M2PP-121-D-PLNM-0008

Site Specific Management Plan 008 - [sectors 480/510]
MacKays to Peka Peka Expressway

31 MARCH 2015 - REV C - CERTIFIED ISSUE

SITE SPECIFIC MANAGEMENT PLAN - TE MOANA [SSMP 8 - SECTOR 480, 510]

Design development

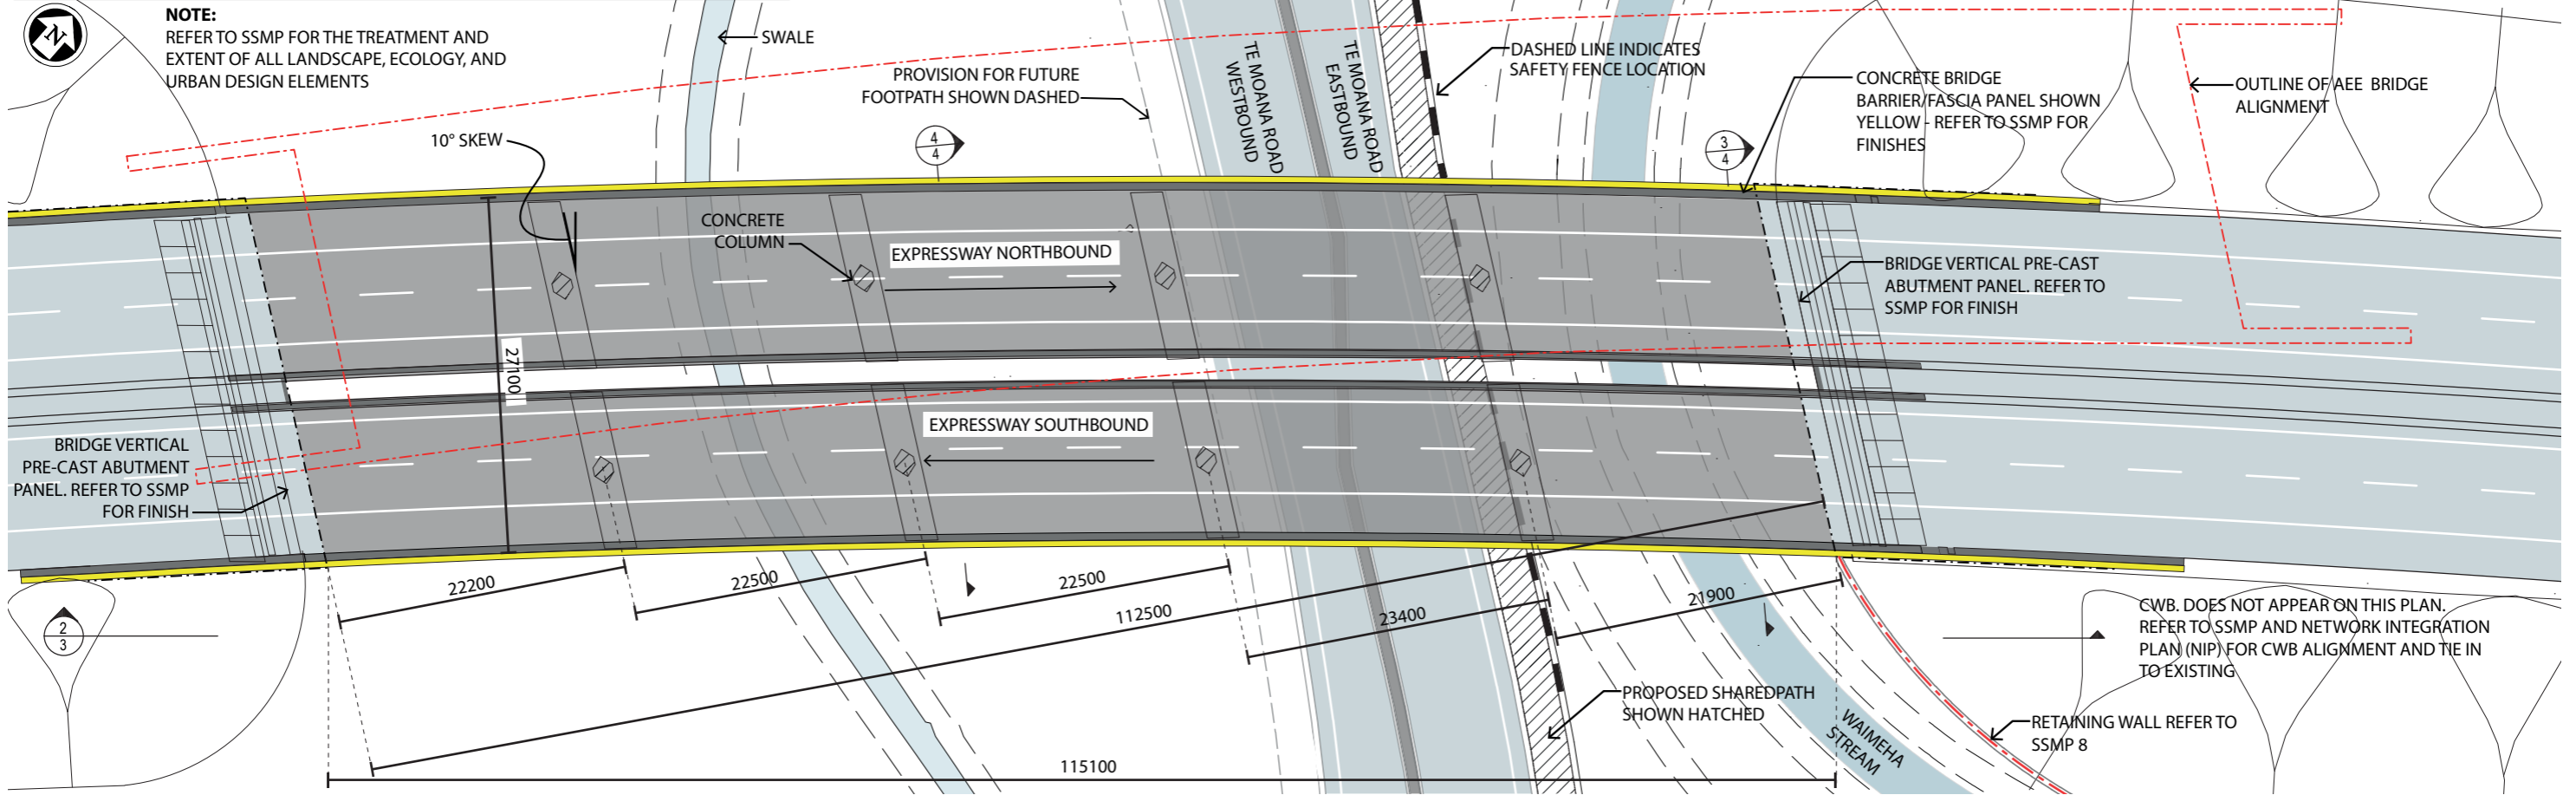
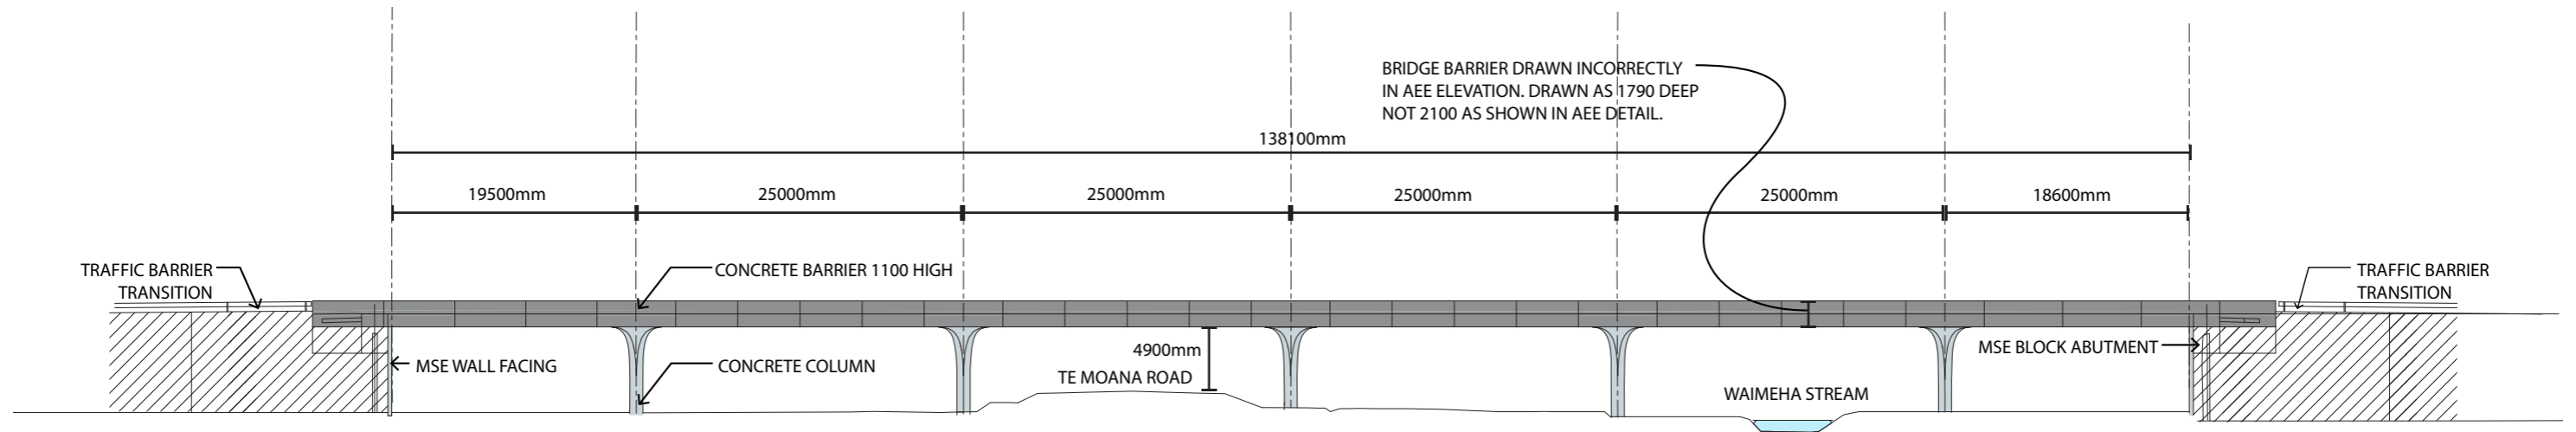
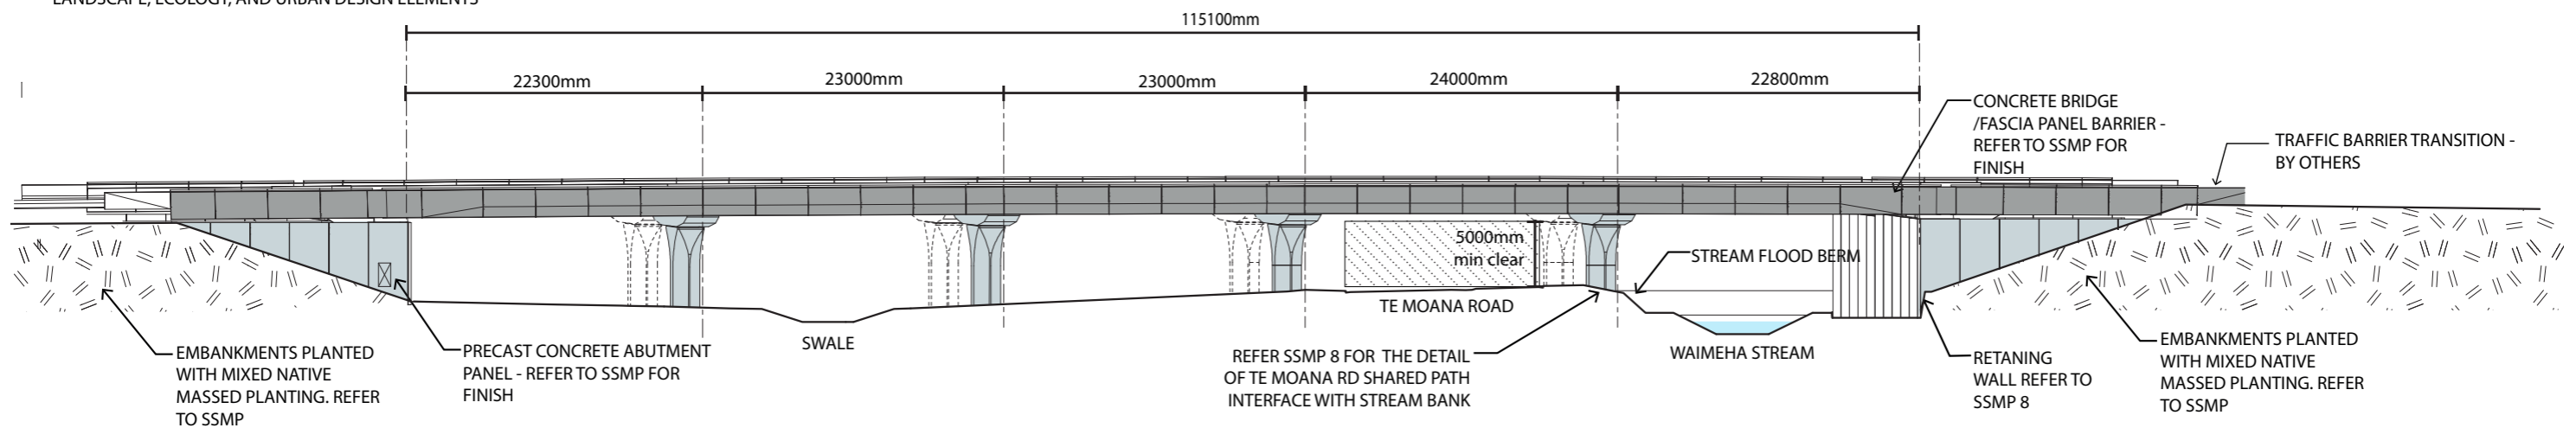
1. Split bridge (1m gap)
2. Remove end span at northern end
3. Column shape and location changed, abutment details refined

1. More consistent span lengths, uniformity of structure
2. Increased structural core based on geotech investigations carried out post AEE, while still providing the sculptural outer.
3. Less stream diversions, removal of northern end span
